Notice of Intent

Sundry ID: 2754851

Type of Action: APD Change

Procedure Description: Mewbourne Oil Company request a variance to perform break testing and offline cementing on the following wells: Querecho 23/26 Fed Com 523H Querecho 23/26 Fed Com 616H Night Watch 2/1 Fed Com 511H Night Watch 2/1 Fed Com 513H Gemini 36/35 Fed Com 513H Gemini 36/35 Fed Com 516H Corona 25/26 Fed Com 525H Corona 25/26 Fed Com 528H Pavo Macho 31/33 Fed Com 616H Pavo Macho 31/33 Fed Com 618H

Figure 1. Cactus 13 3/8" 5M offline cementing tool. Pressure rating limited by the lesser of 5M tool rating or the 13 3/8" pup joint and casing.

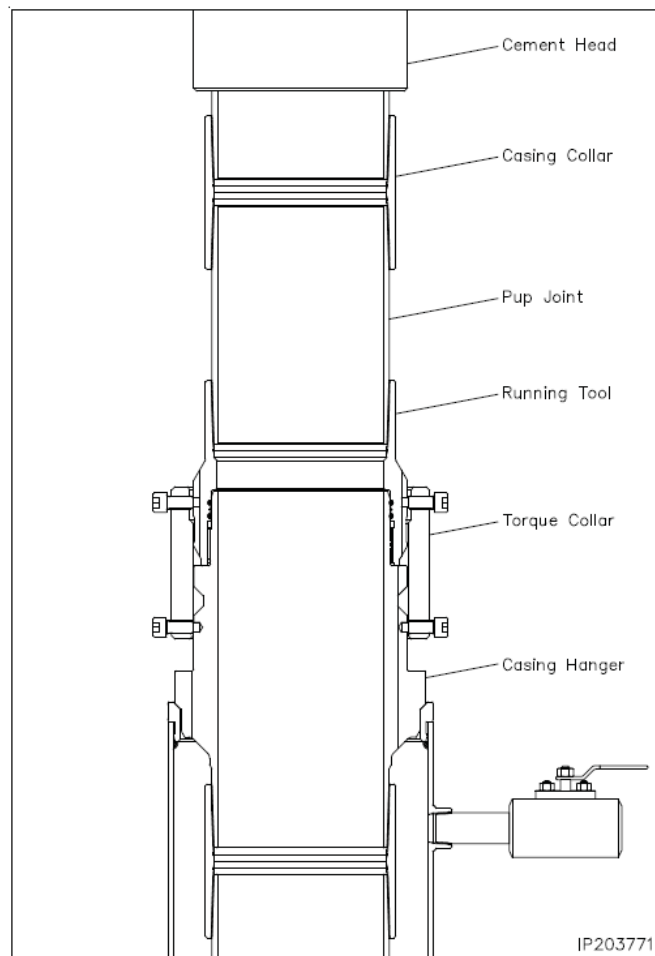
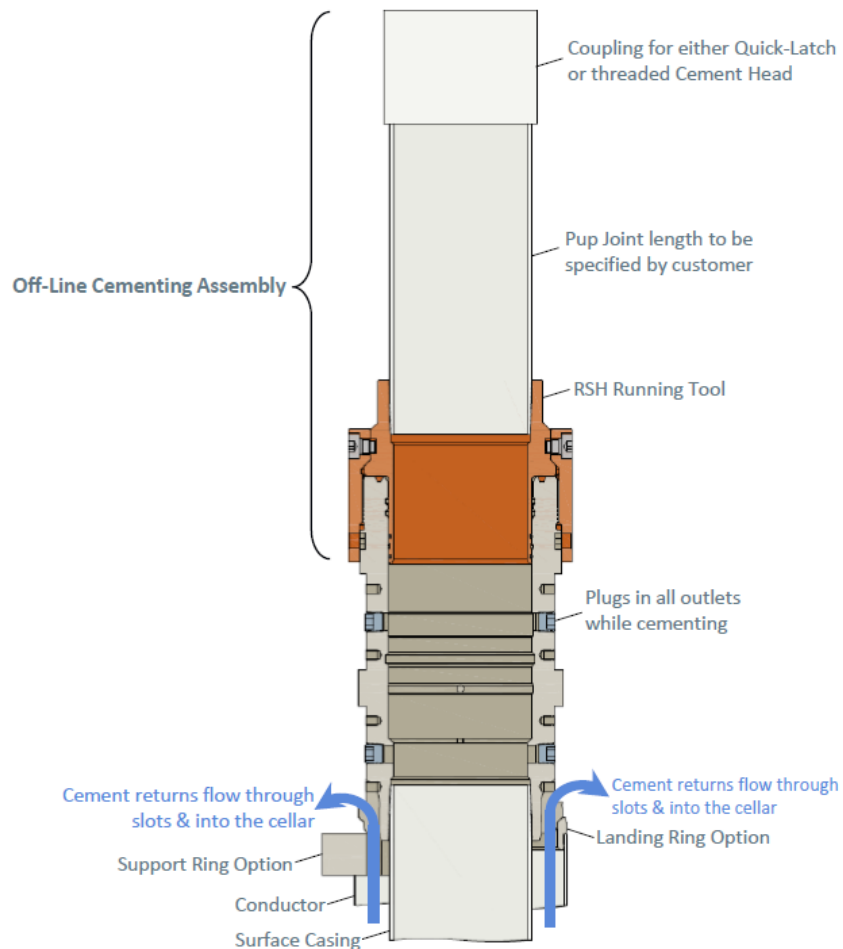
9. Make up offline cement tool with forklift per wellhead manufacturer (Fig. 1 & 2).
10. Make up cement head on top of offline cement tool with forklift.

Figure 3. Cactus 9 5/8" 5M offline cementing tool. Pressure rating limited by the lesser of 5M tool rating or the 9 5/8" pup joint and casing.

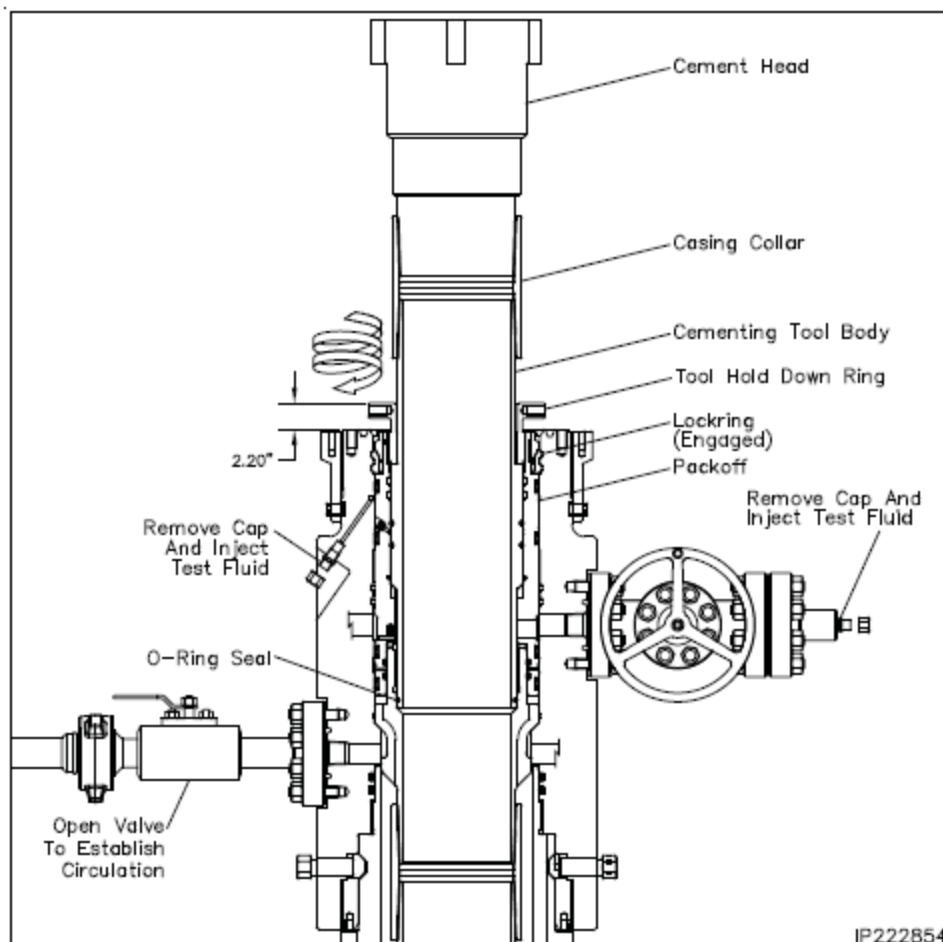
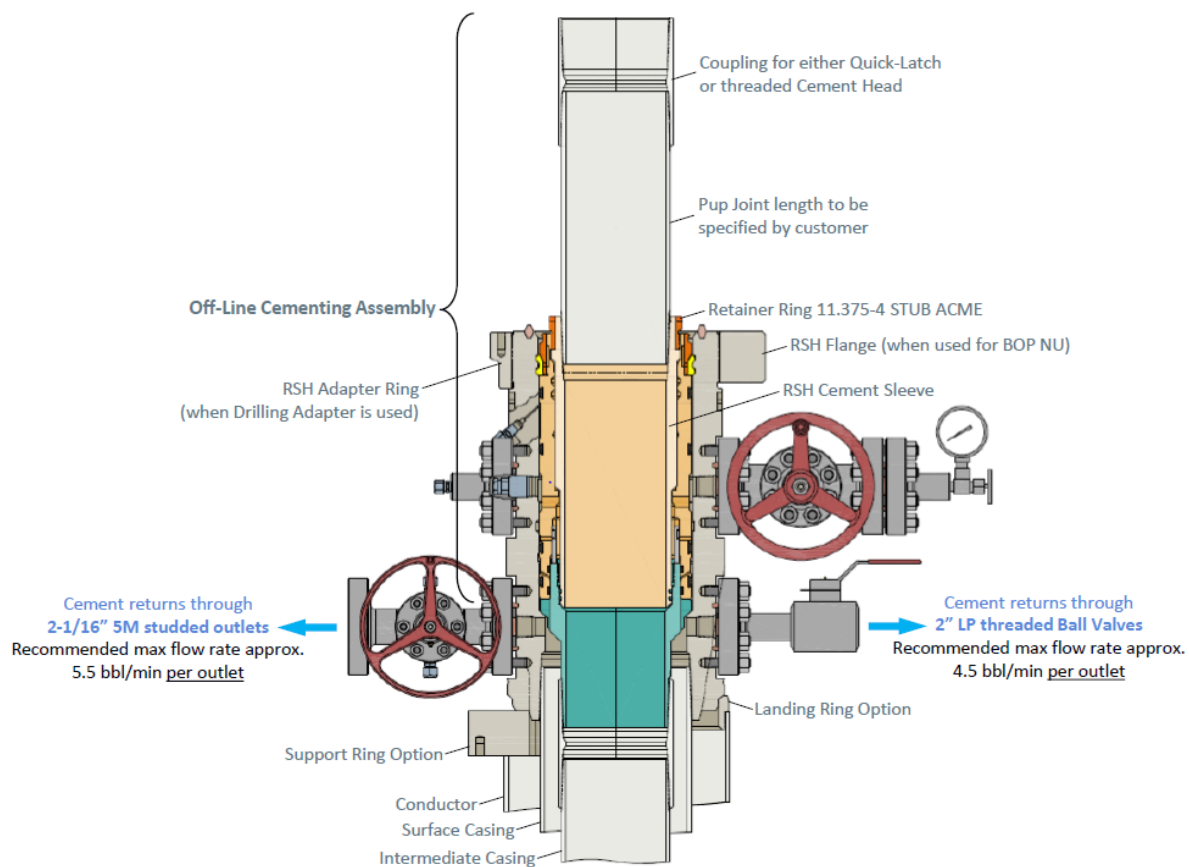
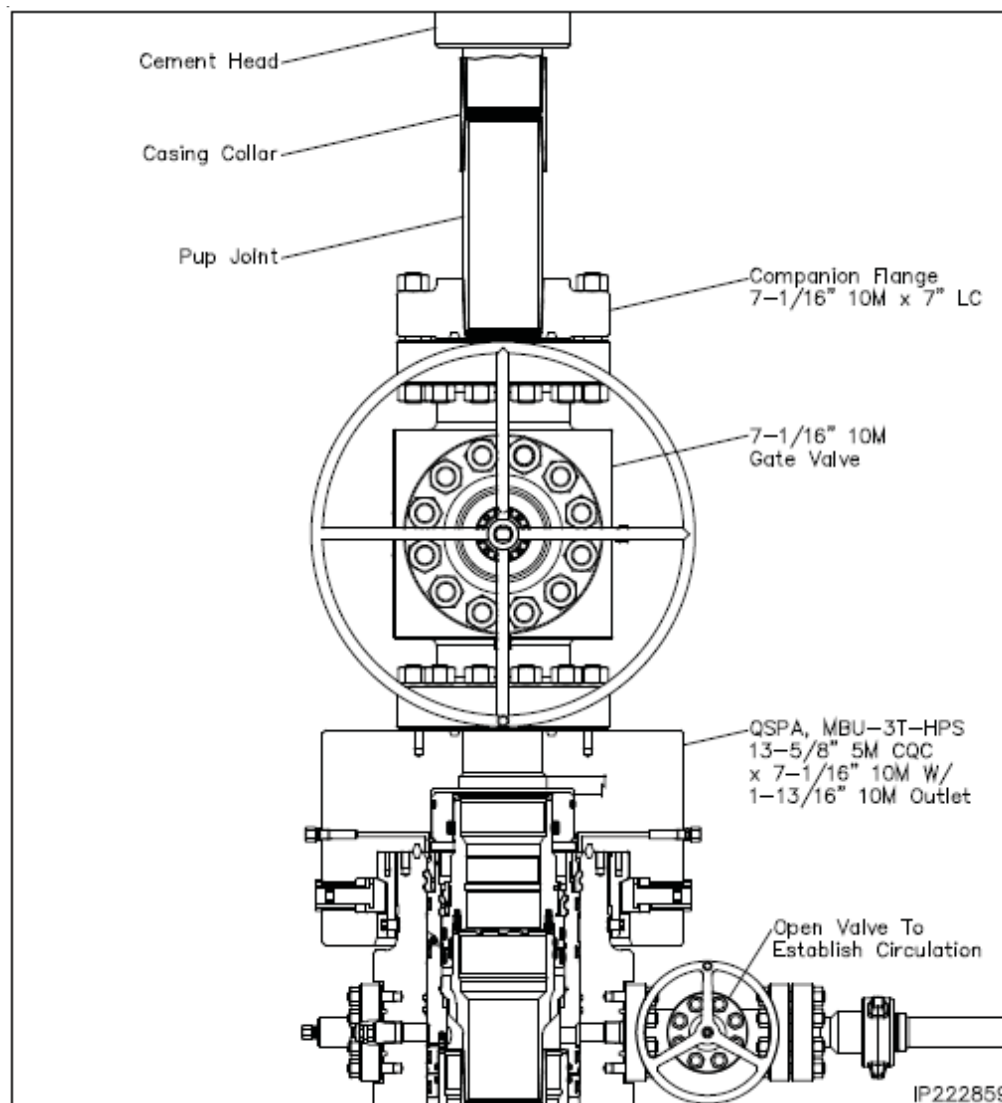
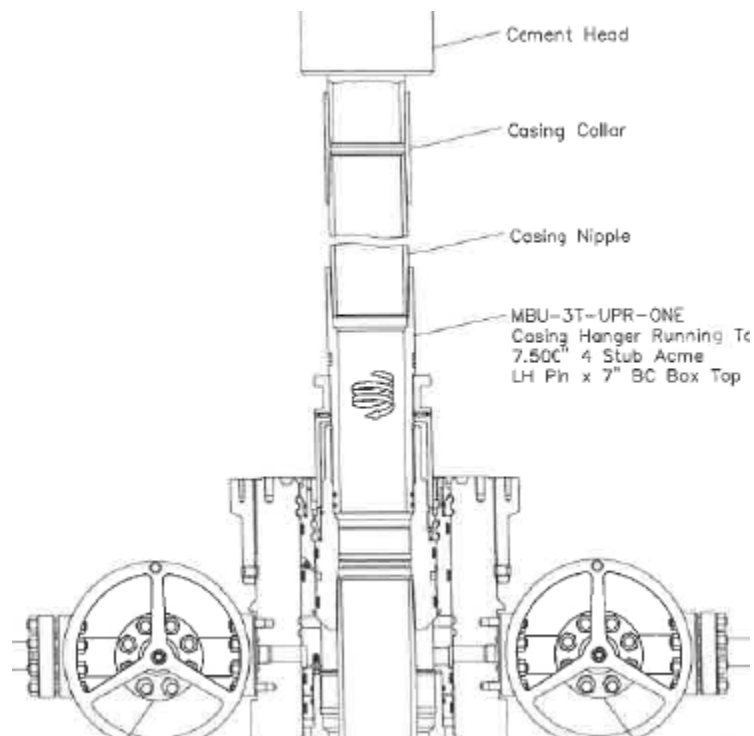
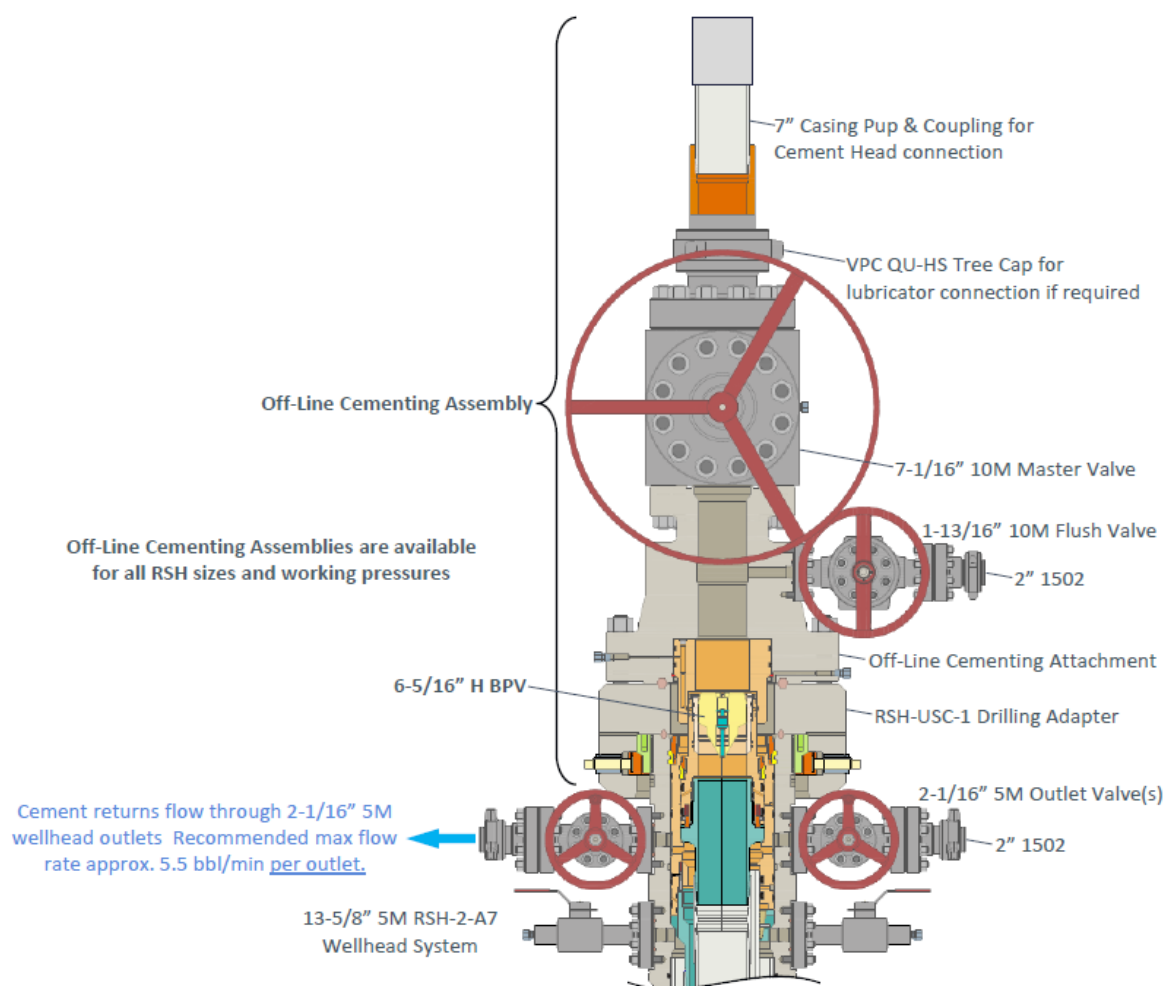
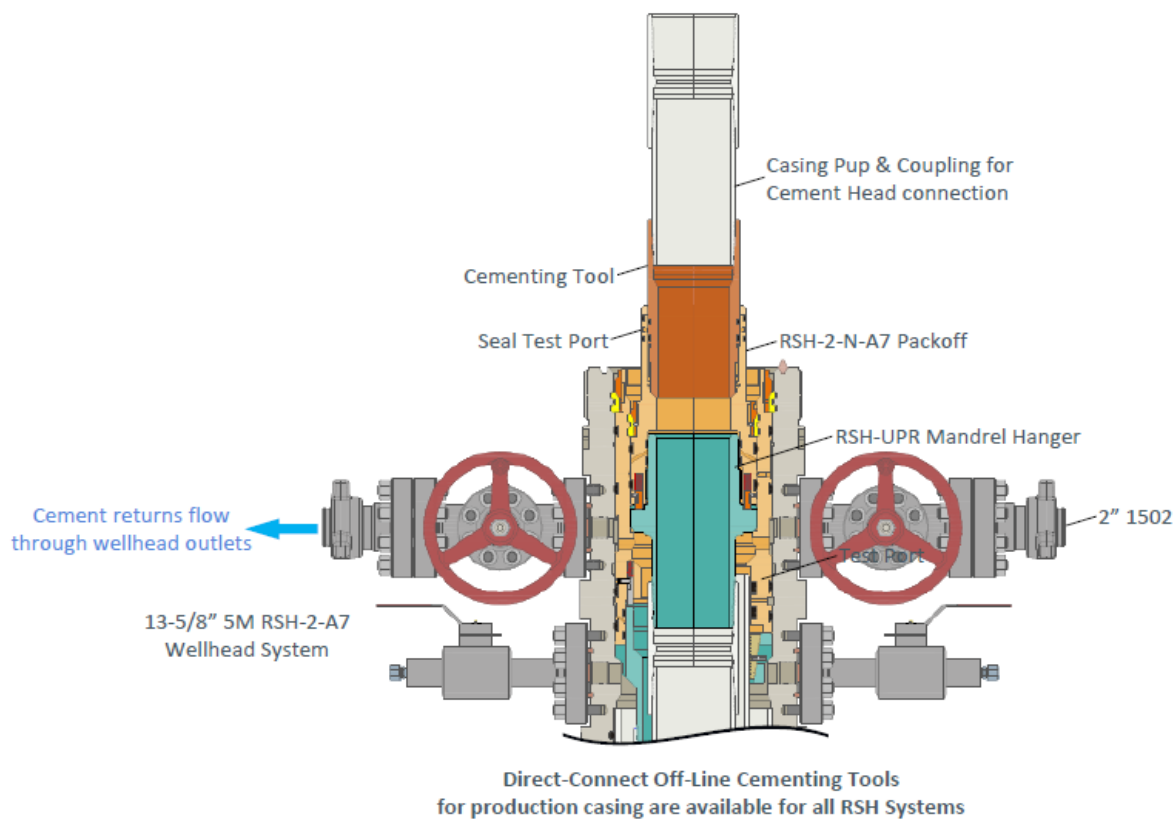
10. Make up offline cement tool using forklift per wellhead manufacturer (Fig. 3 - 8).
11. Make up cement head on top of offline cement tool.
12. Commence cement operations.

Figure 1. BOP diagram

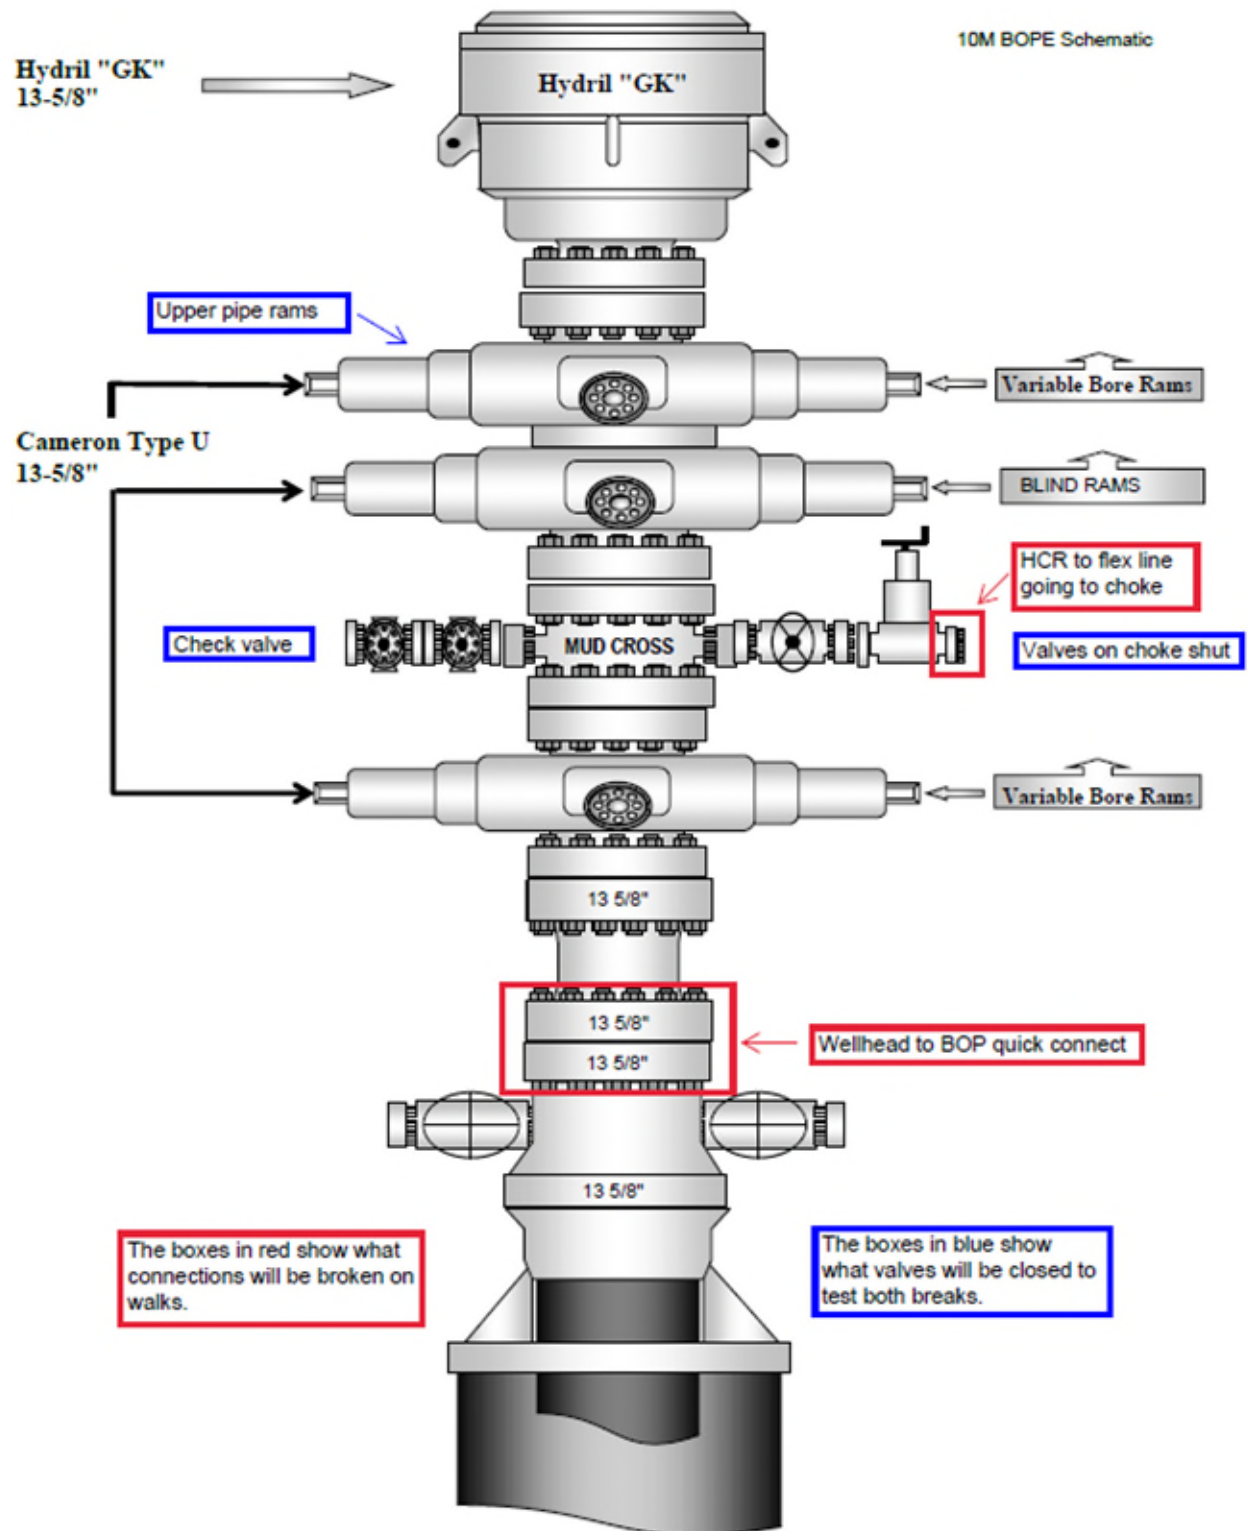
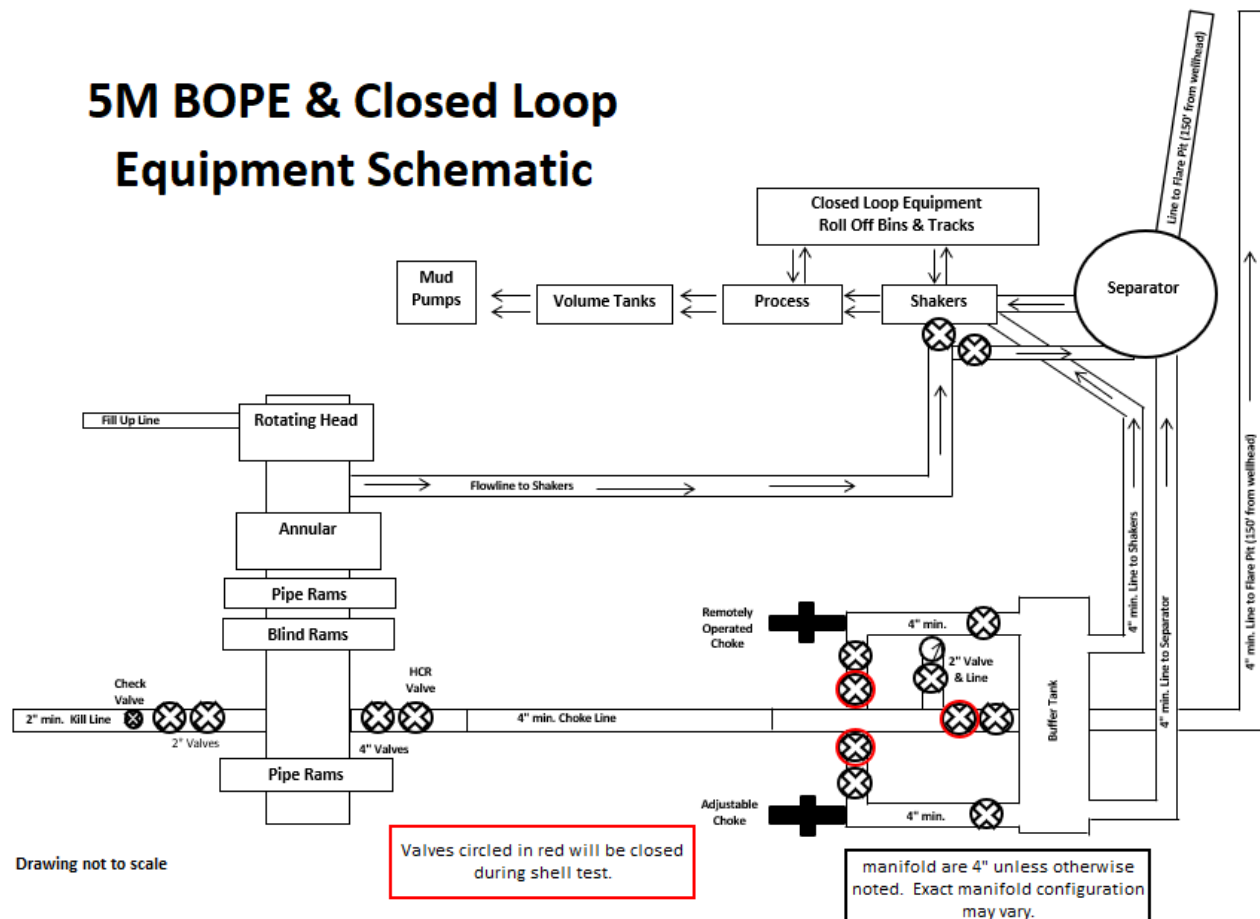
2. After the well section is secured and the well is confirmed to be static, the BOP will be disconnected from the wellhead and walked with the rig to another well on the pad. Two breaks on the BOPE will be made (Fig. 1).

9. A test will then be conducted against the upper pipe rams and choke, testing both breaks (Fig. 1 & 2).
10. The test will be held at 250 psi low and to the high value submitted in the APD, not to exceed 5000 psi.

Figure 3. BOP handling system

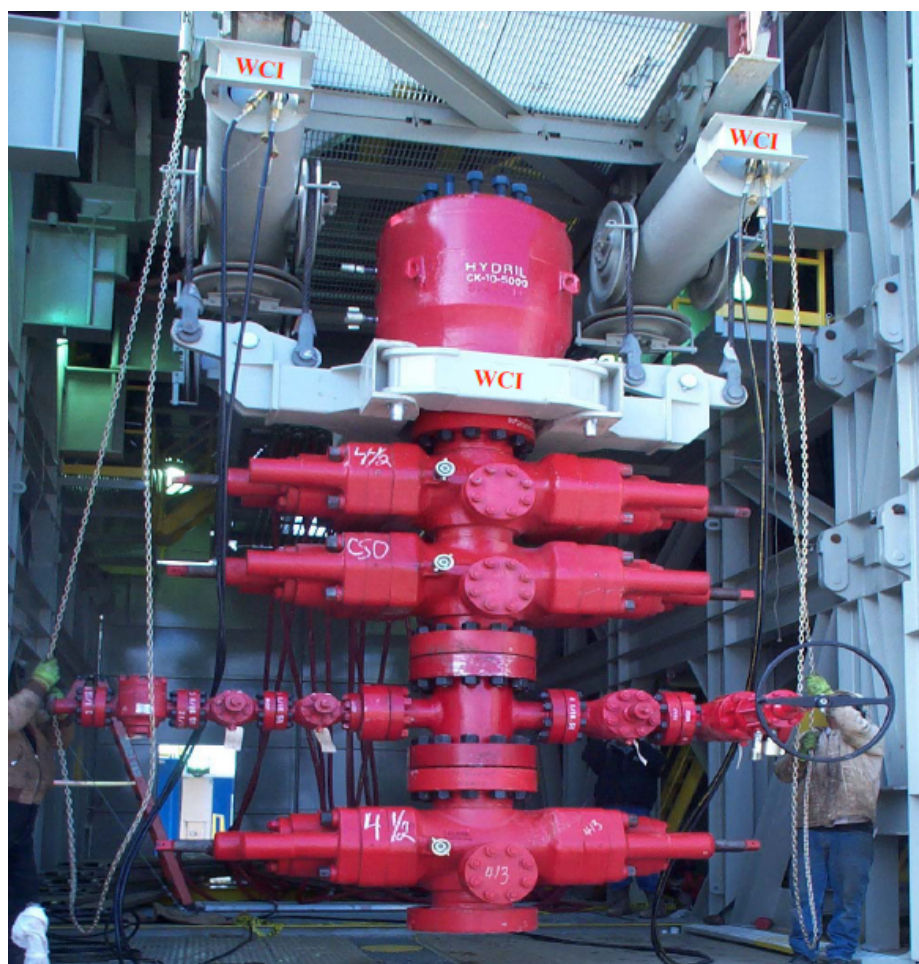
4. The BOP will be removed and carried by a hydraulic carrier (Fig. 3 & 4).
5. The rig will then walk to the next well.
6. Confirm that the well is static and remove the capping flange.
